Proposal #15: 2415-00-71, WISC 2019 008
South 60th Street
W Morgan Ave to KK Rvr Pkwy
Local Street
Milwaukee County

This is Addendum No. 01, which provides for the following:

ADDENDUM NO. 01
PROJECT ID 2415-00-71
November 27, 2018

Addendum No. 01
 ID 2415-00-71
 Revised Sheet 10
 November 27, 2018

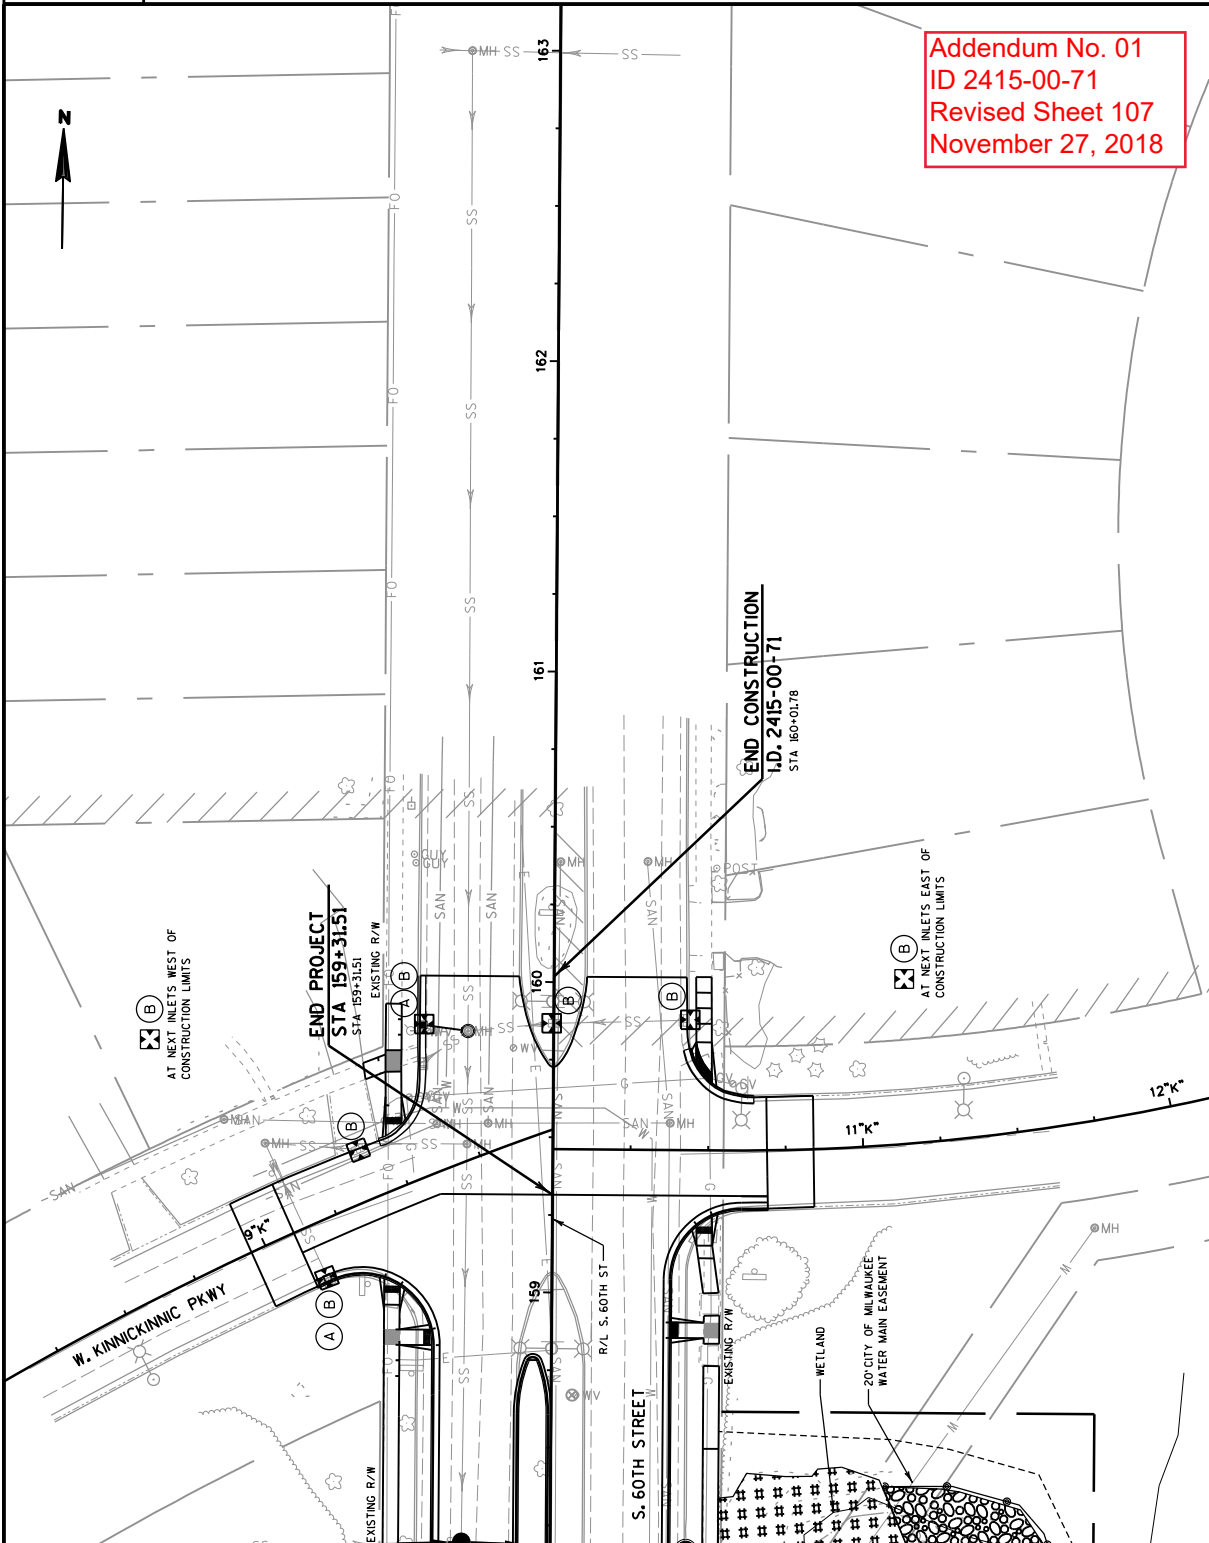
Revised Plan Sheets	
Plan Sheet	Plan Sheet Title (brief description of changes to sheet)
10	Construction Details (Updated Storm Sewer Outfall Detail callouts)
107	Erosion Control (Updated legend)
242	Misc. Quantities (Updated bid item name; added new item)

STORM SEWER OUTFALL DETAIL
